From: Beggs, Tauren R - DNR
Sent: Friday, November 2, 2018 8:53 AM
To: Chris Rogers
Cc: John Emery; Quin Lenz
Subject: RE: Notice to Proceed with Work Plan

Attached is the Site Work Plan for the Allyn Property in Algoma WI.

**ALLYN PROPERTY INVESTIGATION
SITE DETAIL MAP**

111 STEELE STREET
CITY OF ALGOMA, KEWAUNEE COUNTY, WISCONSIN

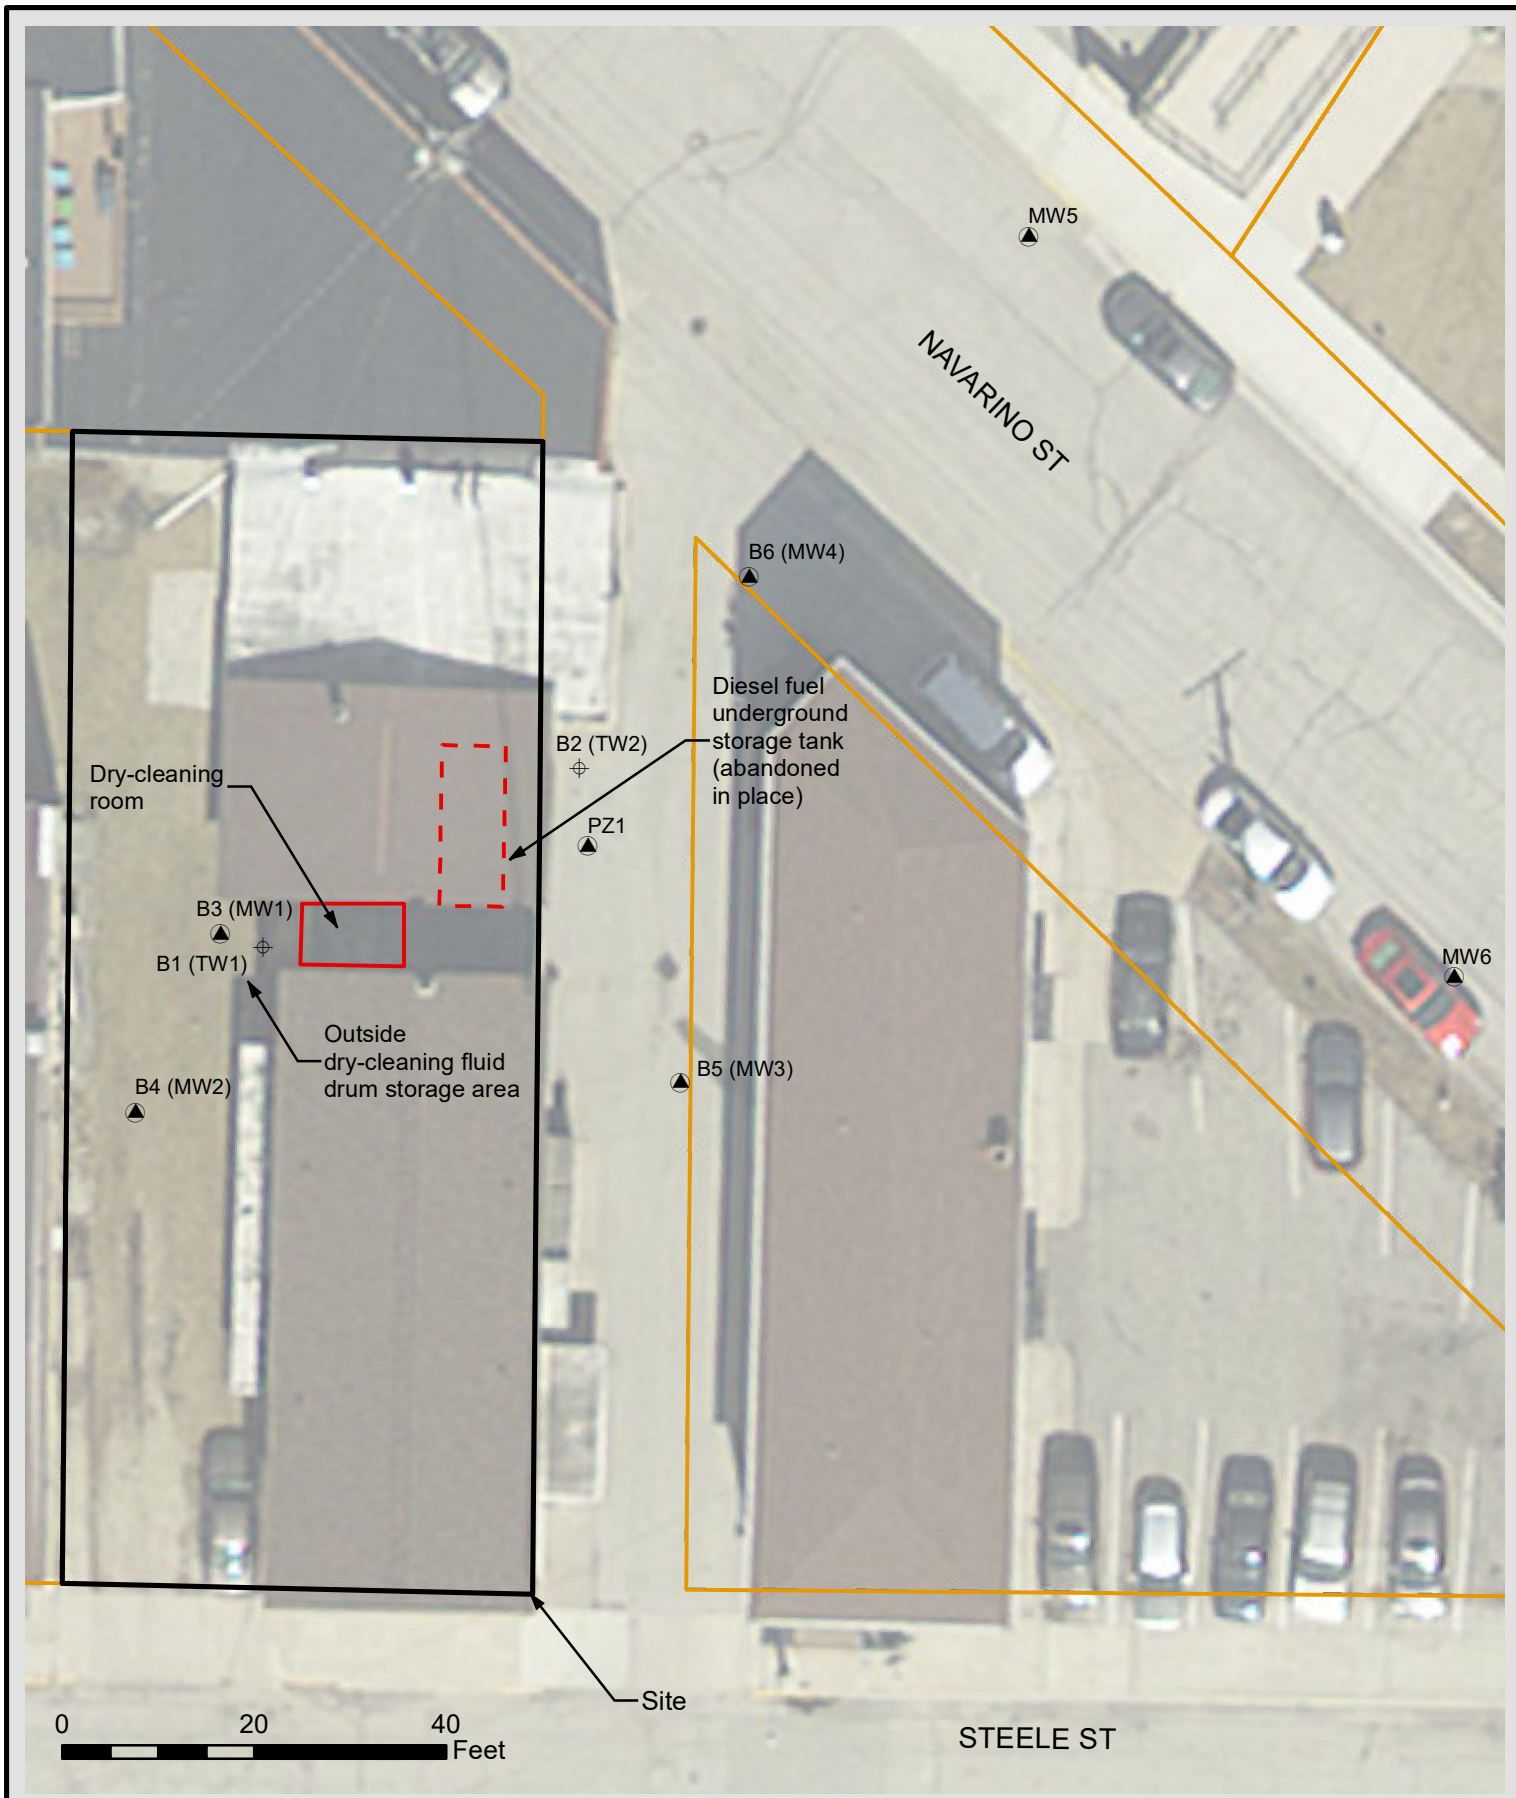
We mobilized to the site on 10/31/18 and installed the 2 monitoring wells and 1 piezometer. We shifted MW5 south and into the roadway. That is as far south as we could comfortably go due to utilities in the area (approximately 40' south of the initially proposed location). Additionally, we had to push MW6 a bit further to the east due to utilities (overhead line).

- Soil samples should be collected at a depth that is unsaturated
- MW05 should be moved further southeast, if possible, to be more in line with existing monitoring wells and groundwater flow direction

Thanks for the update Chris! I am glad you were able to get MW-5 moved further south. Sounds good on vapor assessment, might as well do it all at one time.
